Planning Commission Staff Report

Project Type: Amended Site Development Section Plan

Meeting Date: October 14, 2013

Description: **Larry Enterprises – Lynch Hummer, Lot B (Scott Retail):** Amended Site Development Section Plan, Amended Lighting Plan, Amended Landscape Plan, Architectural Elevations, and Architect’s Statement of Design for a 7.09 acre lot of land zoned “PI” Planned Industrial District located on the west side of Boone’s Crossing on the north side of North Outer 40 Road.

SHEET TITLE:
SITE DEVELOPMENT SECTION PLAN

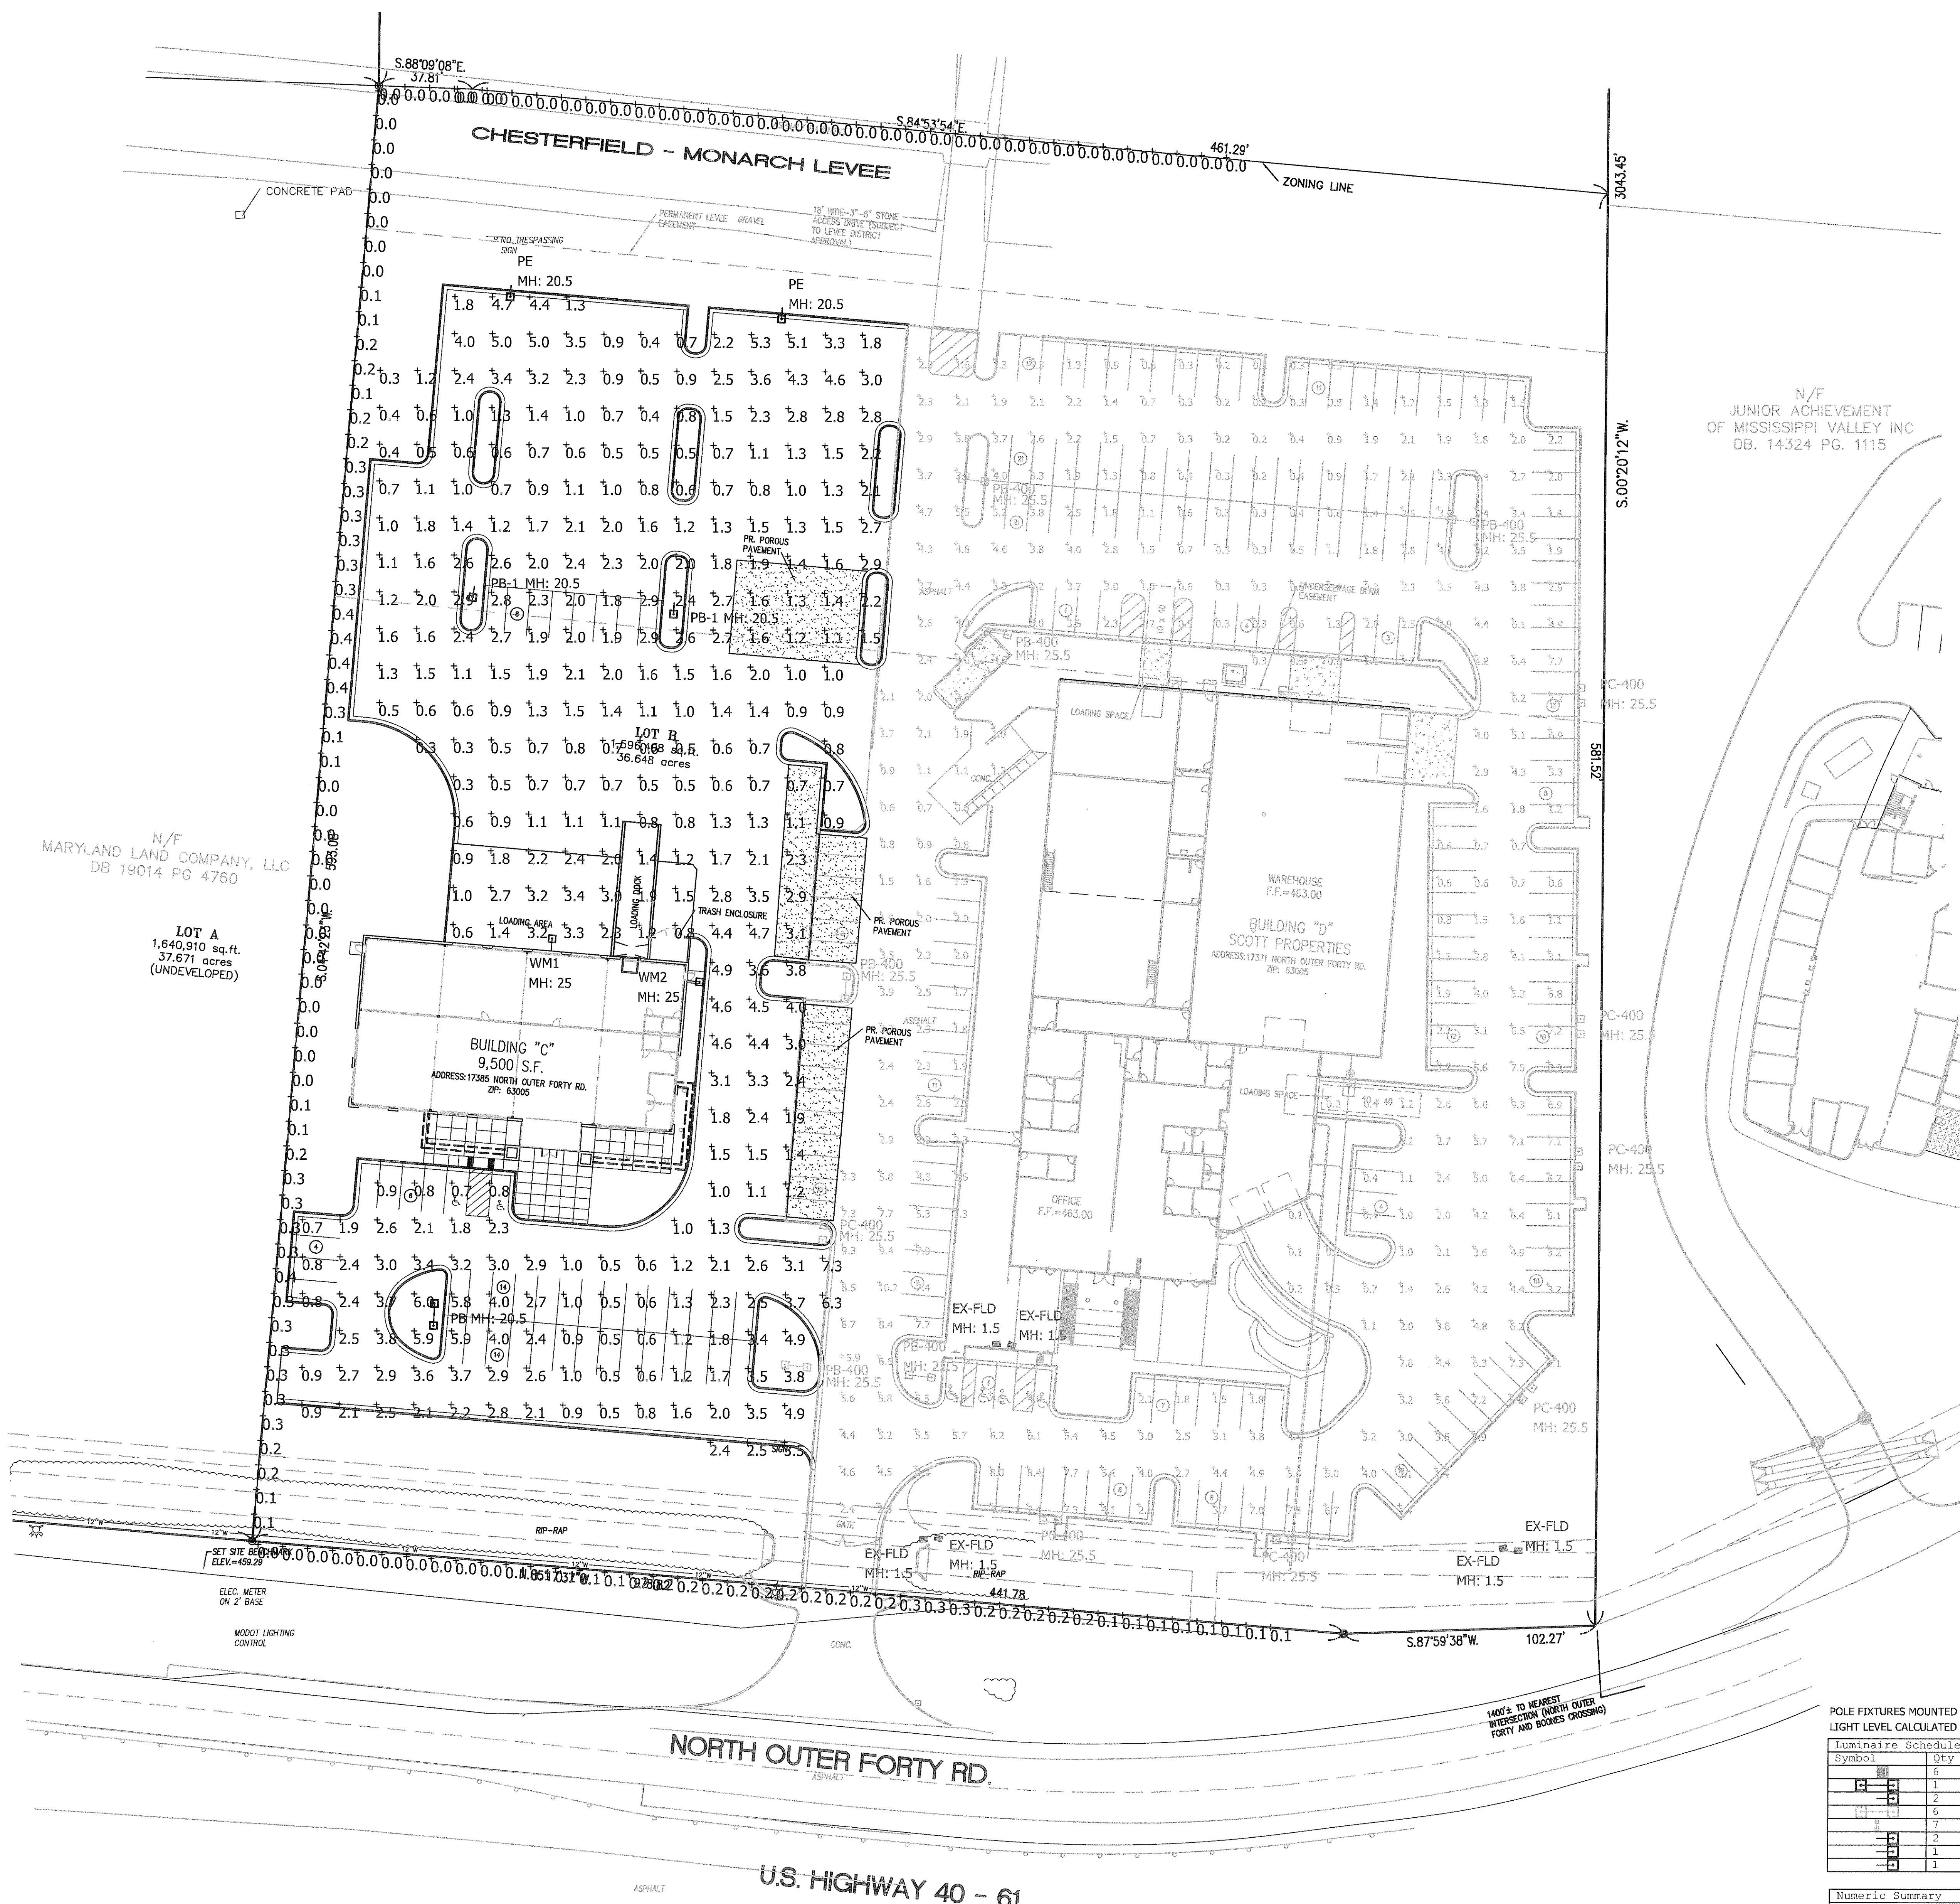
City of Chesterfield Ordinance Number 2055 requires a minimum of 31% green space for the development. The site, as proposed, shows 31.07% green space. Green space is generally concentrated along the levee trail at the northern boundary of the site. The project also includes two large rain gardens located in the southern half of the site.

The plan that was originally submitted for review and that was presented before the Architectural Review Board showed parking that greatly exceeded the City's maximum parking requirements. Although the number of striped parking spaces was reduced to comply with City requirements, the site is still heavily paved to accommodate future outdoor inventory display. These areas are shown on the plan as "outdoor storage" and are located primarily at the rear of the site, with a smaller section along the eastern perimeter of the site.

DRAWN	R. MARDIS
CHECKED	RMM/GJB
DATE	5/6/13
SCALE	1"=30'-0"
JOB No.	2013-120
SHEET	L-1

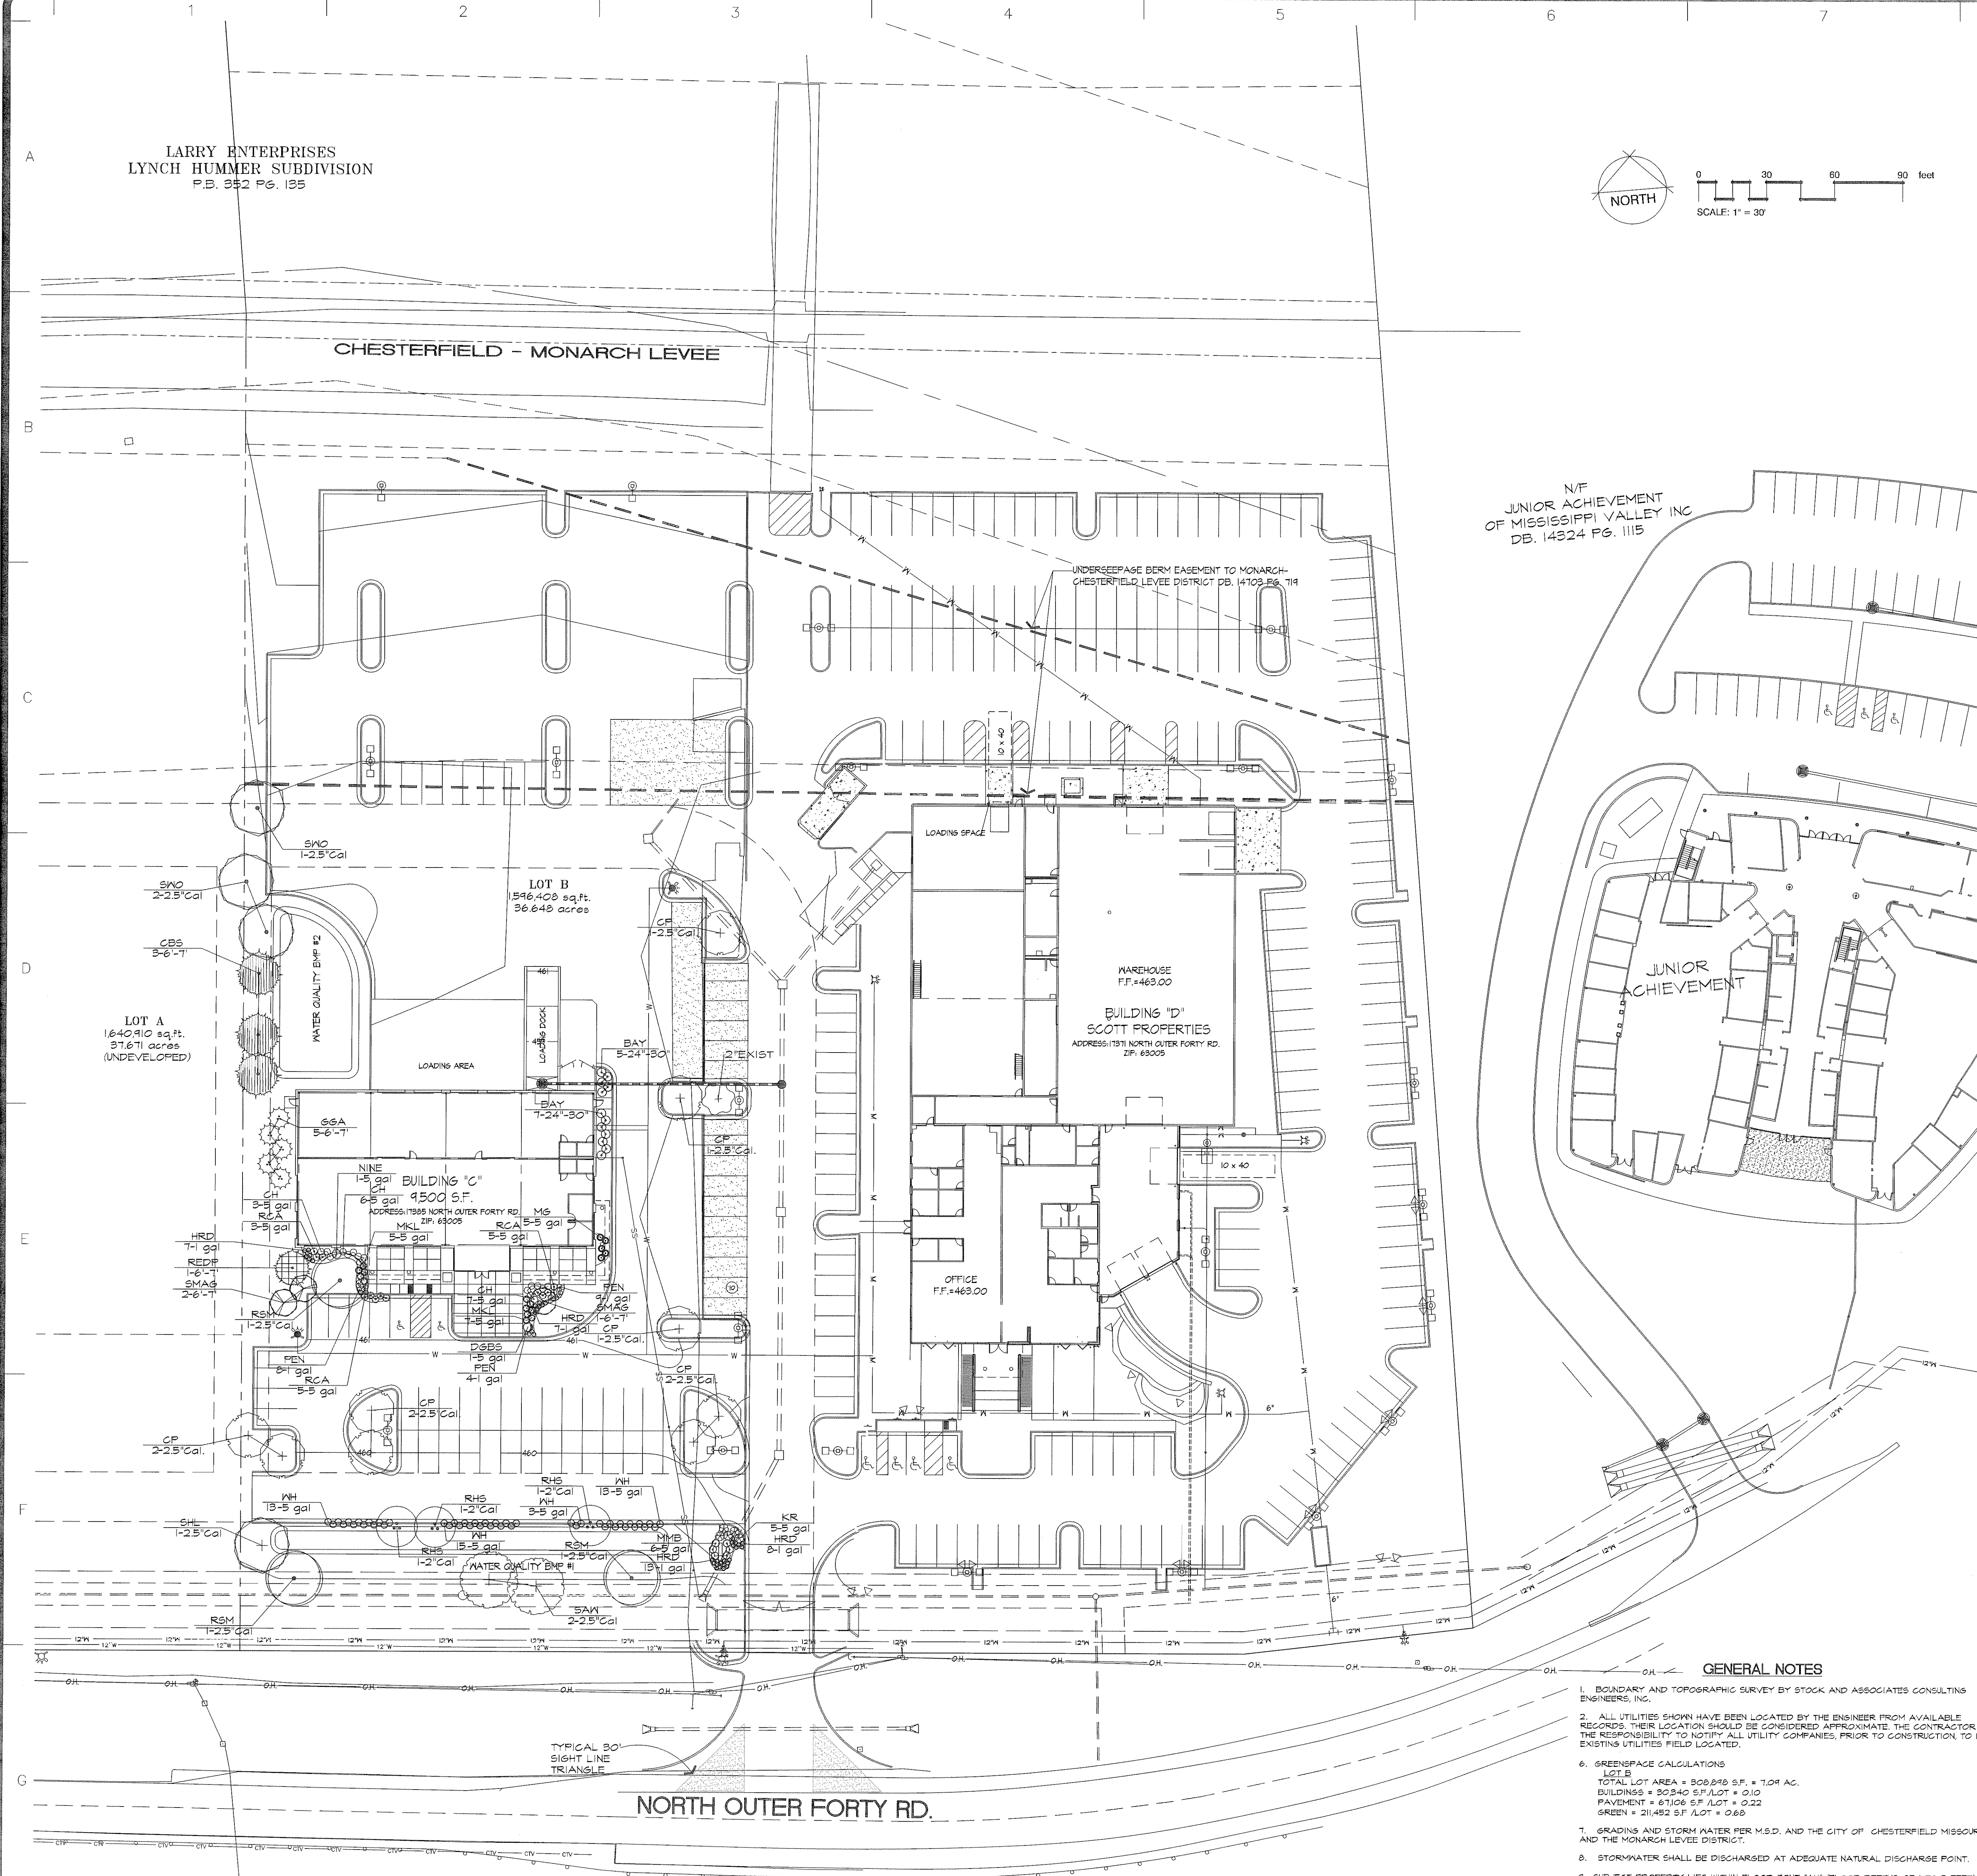
In order to satisfy this requirement, the applicant has proposed to plant two large rain gardens comprised of a mix of native grasses, forbs, and seasonal flowers. The first rain garden that is shown adjacent to the loading dock was included to satisfy a recommendation from the Architectural Review Board.

When the existing Building D was reviewed by the Architectural Review Board (and subsequently approved by Planning Commission), a hedgerow was required along the frontage of North Outer 40 Road in front of the parking field. The proposed design for the addition of the Scott Retail building does not specifically include this hedgerow, but rather, proposes the second rain garden which is to be planted with nine trees and various shrubs around the perimeter to serve as a buffer between the proposed building and North Outer 40 Road.

1. Extra landscaping is to be wrapped around to the north door to the westernmost loading dock.

The motion passed by a voice vote of 4-0. The applicant complied fully with the Architectural Review Board's recommendation.
